Sutton Courtenay Parish Council

Minutes for a meeting of the Parish Council held on Tuesday 6th October 2026 at Sutton Courtenay Village Hall, commencing at 7.15pm.

Sutton Courtenay Parish Council Formal Objection

Ref: P26/V1357/RM

Figure 3.7: Extract of Stantec Pluvial Model Extents

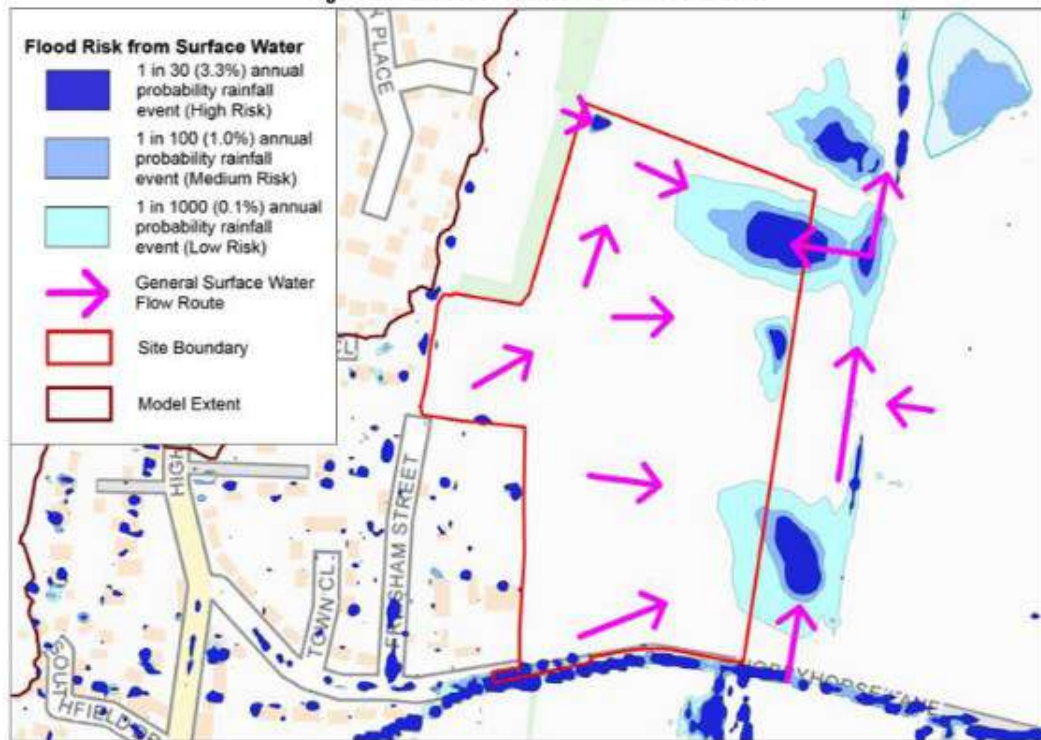
The modified /enhanced flood risk assessment map produced by Stantec, while a significant improvement on the original maps only represents what is becoming the normal runoff and ponding for this area and in my view does not sufficiently represent outlier events, i.e. the 1:30, 1:100 and 1:1000 year events. Anyone who lives in the village and walks around this area knows that during winter the eastern edge of the field regularly floods and spills over the footpath to the east.

Figure 1 Proposed Infiltration Basin and Areas where Infiltration is Feasible**Figure 2 Proposed New Layout, Catchments and Drainage Basins**

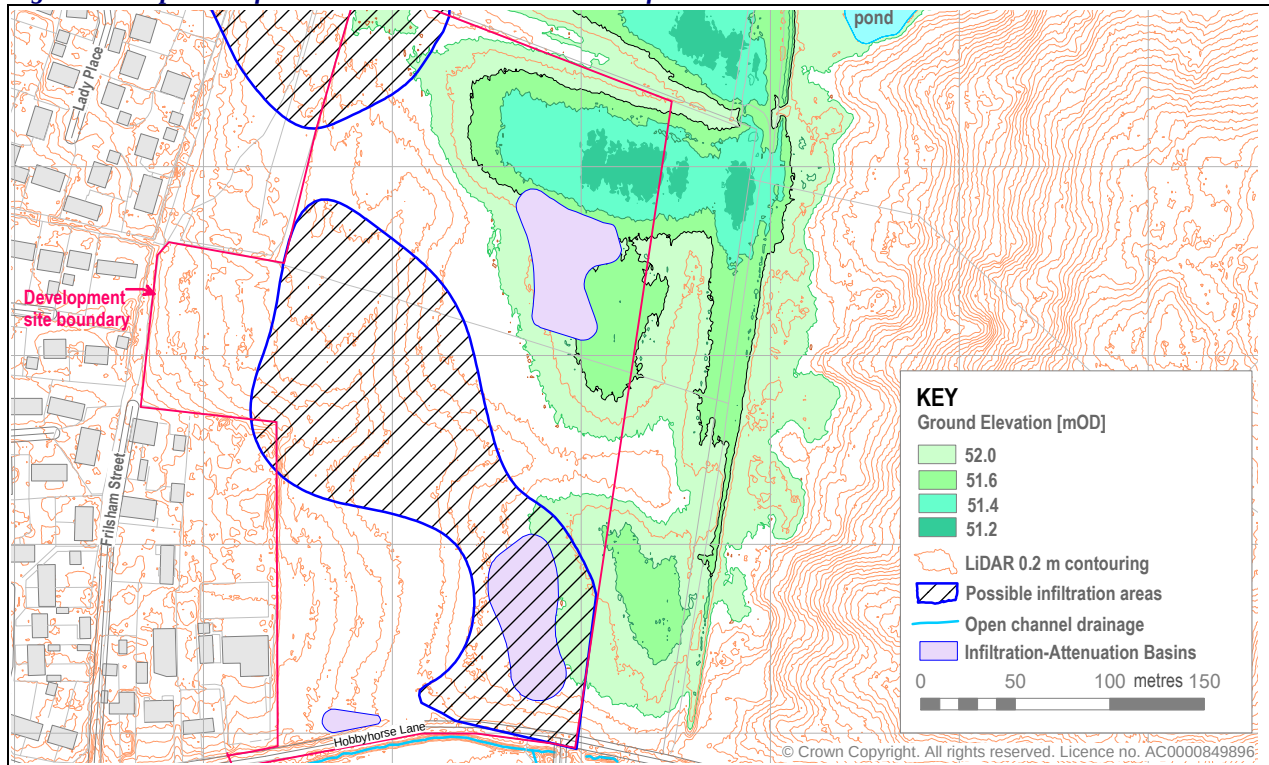
The proposed scheme also continues to rely on **ground raising** [Stantec Section 4.8.9], in particular as the Infiltration Basin North occupies low-lying ground with seasonally high groundwater levels. This is shown in [Figure 1](#). The extent of ground-raising will still be substantial, in particular in the area of infiltration using imported filter media.

Although dispersed soakaways scattered across the central part of the planned urban area are no longer shown, the proposed site layout continues to rely on widespread **permeable paving** to allow infiltration. However, a robust conceptual model and understanding of the shallow hydrogeological processes has not been presented, especially as these processes will be altered during construction and earth-moving activities, which generally compact the ground surface. The abandoned soakaways are shown in [Figure 2](#) on the new drainage network and catchments.

There has been no further detail on the **construction of the Infiltration Basin North**, in particular with respect to freeboard, infiltration rate achievable and stability of the steep basin embankments shown in the original design. The infiltration rate given in the RSK drawing is 35.8 mm/hr, a surprisingly precise number given the lack in information on materials. This contradicts the value given in the report text of 32 mm/hr. These values in fact appear to have been derived from trial pit soakage tests, the nearest being SA102, which was tested to an infiltration rate of 35.8 mm/hr. This is therefore local in-situ materials and not the engineered basin.

Furthermore, the infiltration basin is shown on RSK drawings with an invert level of 52.2 mOD, which is the same as the original design. This basin lies in an area with 0.35 to 0.45 m depth to winter groundwater and existing ground level of 51.7 mOD, that is an approximate freeboard of only 0.5 m, not the required 1 m. The design therefore remains flawed and does not comply with SuDS guidelines.
